Report to the Chairmen, Committees on
Appropriations, House of Representatives
and U.S. Senate

TRAINER AIRCRAFT

Plans to Replace the Existing Fleet

B-231330

Figure 4.1: Comparison of Planned T-37 Utilization With Available Aircraft

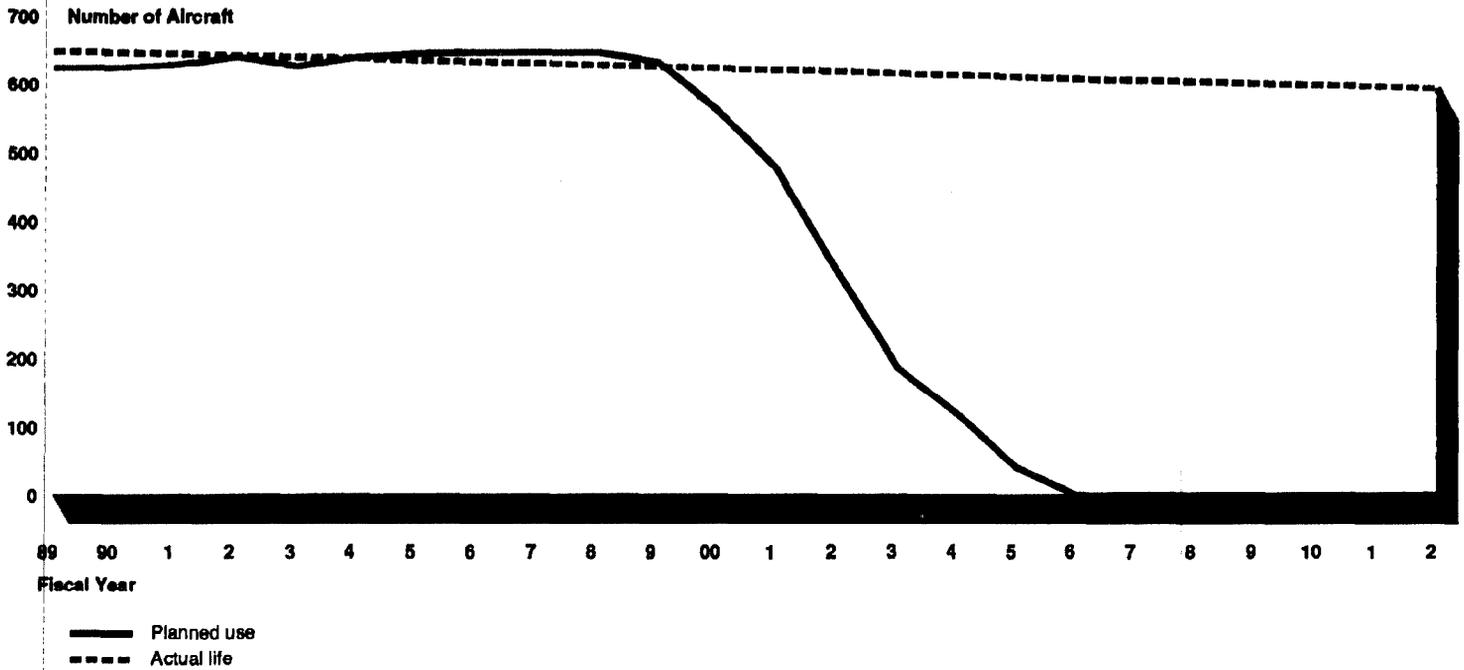
The Air Force plans to initiate a service life extension program for its 643 T-37 aircraft assigned to ATC at an estimated cost of \$197 million. The program, as described in the master plan, will consist of replacing six critical structural components that are not practical to inspect at field level, but it will not address the operational deficiencies identified in chapter 2. When the program is completed, the Air Force expects the T-37 to meet UPT requirements and remain airworthy past the turn of the century. Yet, because the Air Force believes it needs new aircraft to address the operational deficiencies of the T-37, it plans to buy about 100 aircraft to replace its T-37 fleet, beginning in 1998, well before the end of the T-37s flyable life (see fig. 4.1).

In its updated February 1989 master plan, DOD revised the scope of its T-37 modification program. According to DOD, rather than an increase of 15,000 hours estimated under the original modification program, the revised program would provide 8,000 hours of additional operation before a replacement aircraft or additional inspection is needed. According to the updated master plan, the next major inspection cycle after modification would occur in the 2005 to 2007 time frame. Thus, replacing the T-37, beginning in 1998, still does not fully utilize the aircraft.

Figure 4.2: Comparison of Planned T-38 Utilization With Available Aircraft

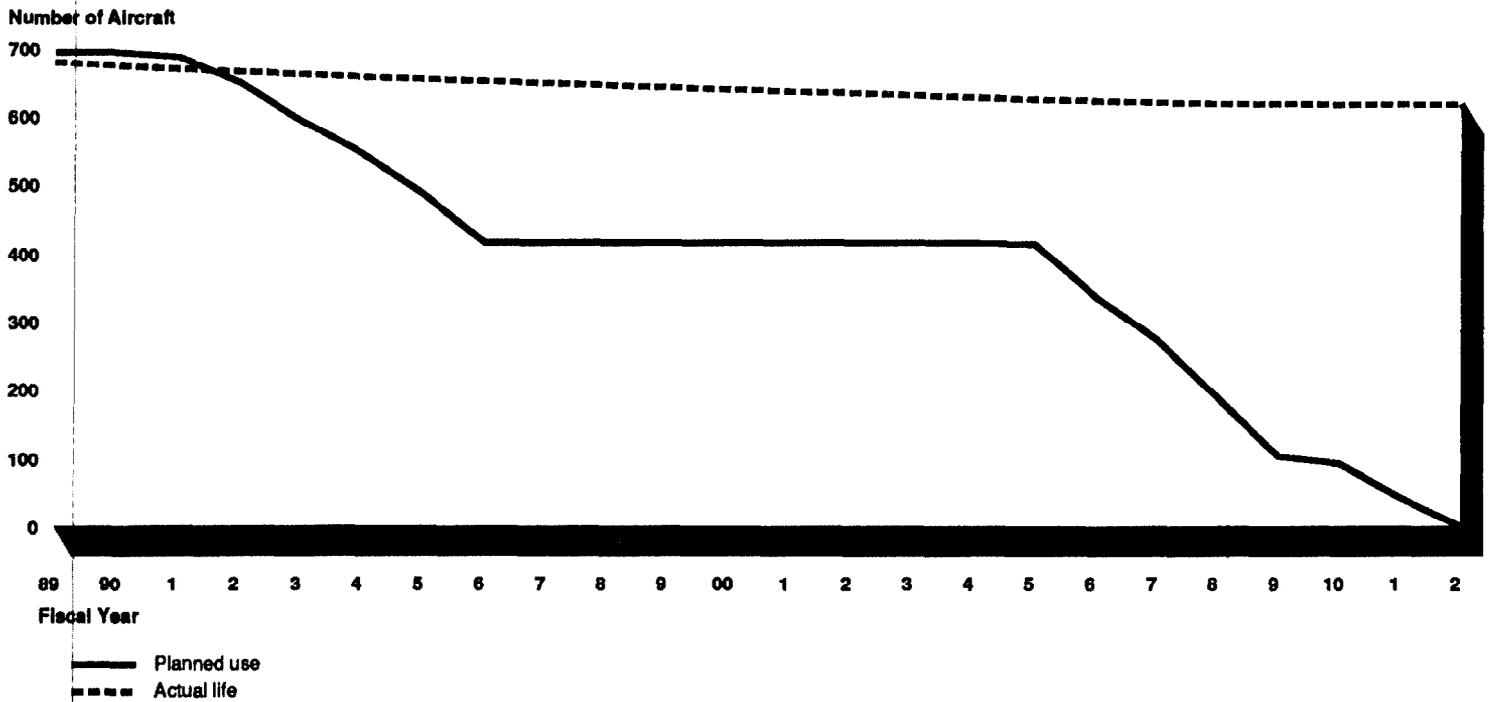
In fiscal year 1986 the Air Force began a modification program to extend the useful life of its 679 T-38 aircraft assigned to ATC. The program, estimated to cost \$315 million, is a 10-year effort and consists of 7 structural modifications. According to the Air Force, once the modifications are complete, the T-38 will support pilot production, at current rates, until 1996, and over 600 aircraft are expected to be airworthy past the turn of the century. As with the T-37s, these modifications will not address the operational deficiencies identified in chapter 2. To

address the operational deficiencies and implement the dual-track system, the Air Force plans to buy about 200 new aircraft to replace some of its existing T-38 fleet, beginning in 1991, well before the end of its flyable life (see fig. 4.2).

T-37s Available vs PATS Deliveries

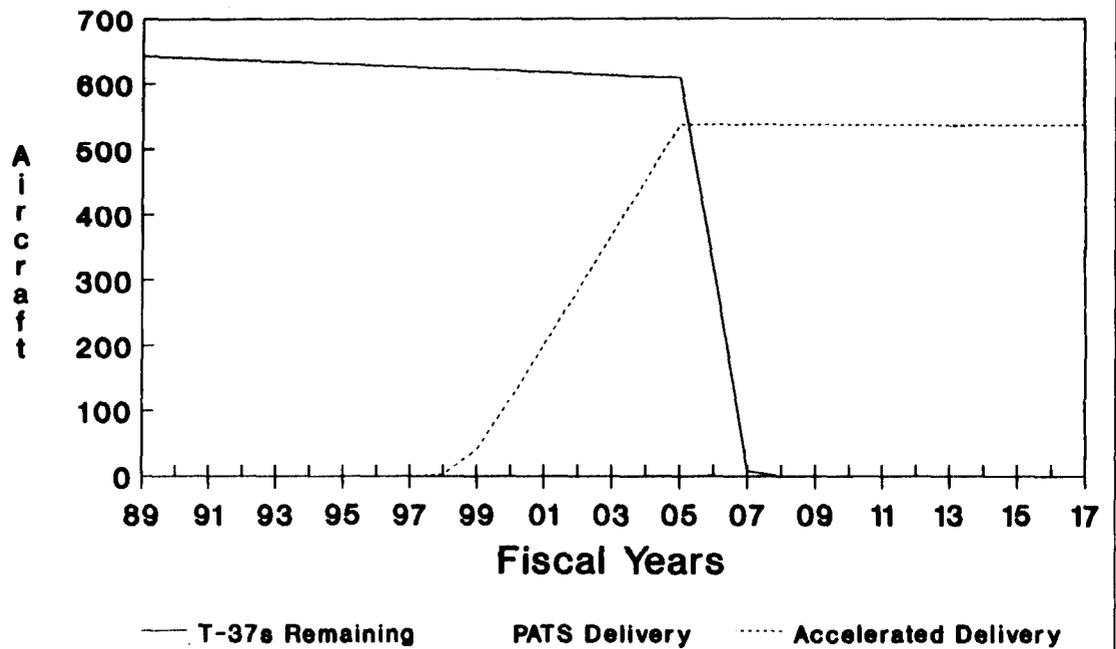
DOD Response: Partially concur. The Air Force does not plan to replace the T-37 and T-38 well before the end of their useful life has been reached. As stated above, there are compelling reasons from a quality of training standpoint for replacing the current fleet according to the existing timetable. From the T-37 structural standpoint, the argument is equally compelling. At the time the 1988 Masterplan was being prepared, the T-37 Structural Life Extension Program (SLEP) was envisioned as a program which would add another 15,000 hours of service life to each aircraft modified. After the plan was submitted and during the time that the GAO audit was being conducted, the T-37 SLEP underwent a significant modification which reduced the scope of the proposed overhaul. It is now anticipated that the revised SLEP will provide approximately 8000 hours of additional operation before a replacement aircraft is required or another significant inspection must occur. The impact of this 8000 hour life extension is shown in Attachment 1.

SUPT FUNDING Delayed TTTS

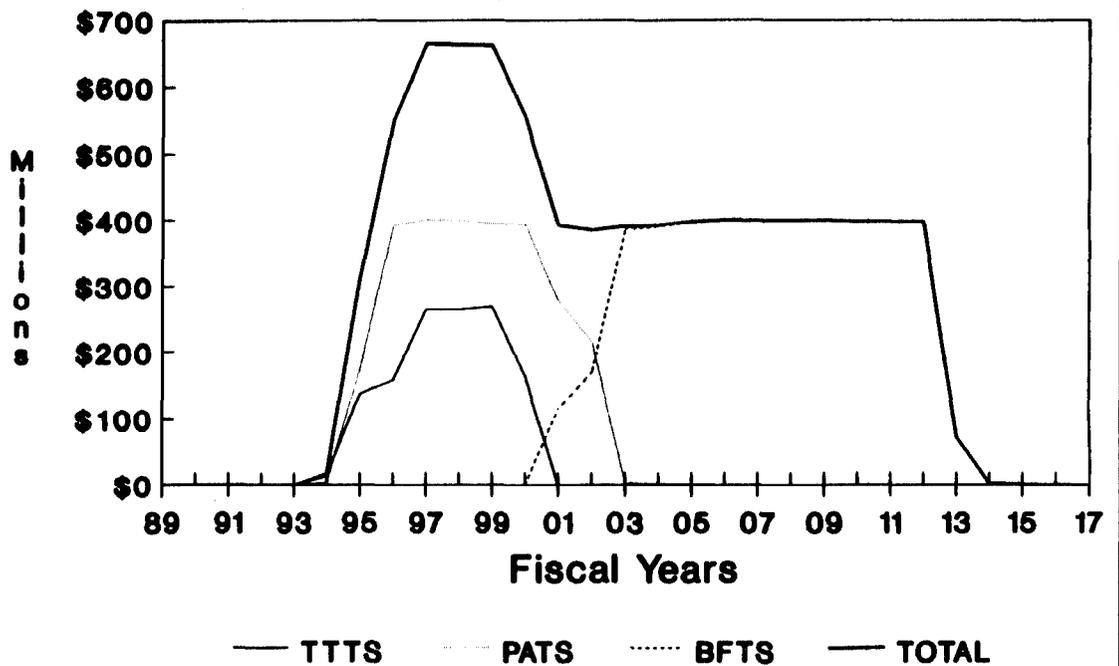
At projected use rates, additional action or replacement is required by the year 2006. Attachment 2 depicts the rate of T-37 replacement deliveries compared with the projected rate of T-37 retirements. Replacement of the T-37 as outlined in the 1988 USAF Trainer Masterplan occurs just in advance of the anticipated loss of T-37 airworthiness.
